Town of Guilford, Connecticut
Bid #1-1819
Calvin Leete Elementary School
Subsurface Sewage Disposal System Replacement

Addendum No. 1

July 25, 2018

**TEMPORARY PAVEMENT
TRENCH REPAIR DETAIL**

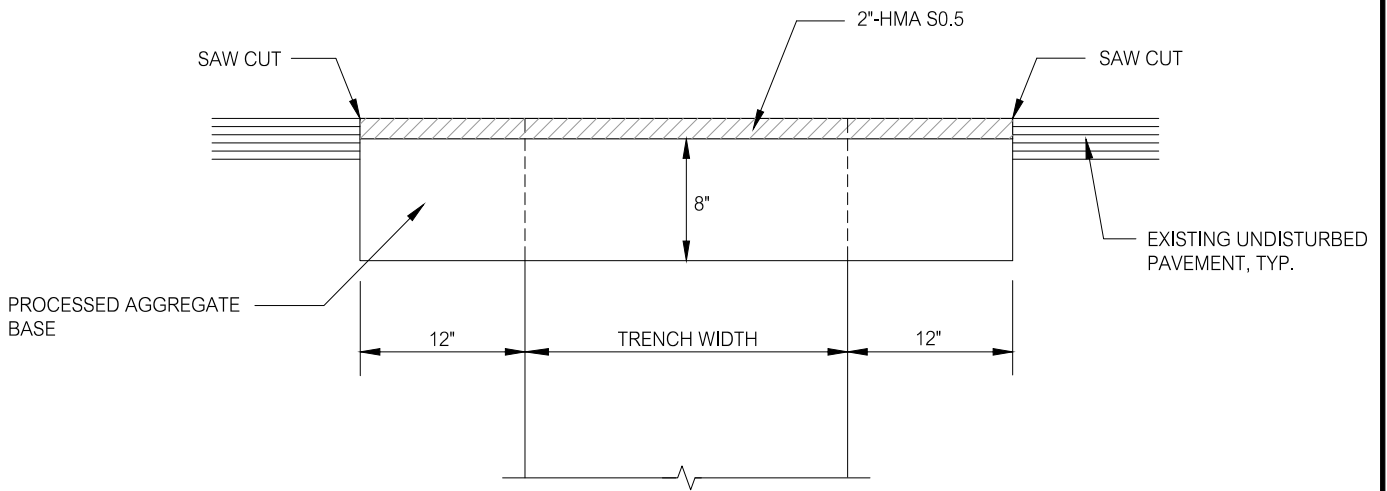
8. As indicated in the Contract Documents, temporary fencing will be required to be installed to separate the Contractors work limits from the operation of the school facilities.
9. As indicated in the Contract Documents, the Work includes the removal of the existing effluent sewer.
10. The original design drawings for the existing septic tank indicate wall thicknesses of ten (10) inches and a roof slab thickness of eight (8) inches.
11. As indicated in the Contract Documents, the Work includes the removal of the existing bituminous concrete pavement and the installation of a 2" course of new bituminous concrete pavement.

(Note: See Paragraph D. below for modification subsequent to the pre-bid conference.)

1. A Lump Sum Bid price for the Work required to remove the existing bituminous concrete pavement and place new 2" thickness bituminous concrete pavement as shown on the Contract Drawings shall be included as Alternate No. 2-Bituminous Concrete Pavement.
2. The Work required under the Base Bid shall include the provision of temporary bituminous concrete trench repair for the trench excavation required to remove the existing effluent sewer where it is located within the existing bituminous concrete pavement area. The temporary trench repair shall be in accordance with the Temporary Trench Repair Detail shown on the attached SK-1 drawing.
3. The Bid Proposal Form shall be replaced in its entirety with the attached revised Bid Proposal Form.

MATCH EXISTING ADJOINING PAVEMENT SURFACES
WITH TEMPORARY PAVEMENT.
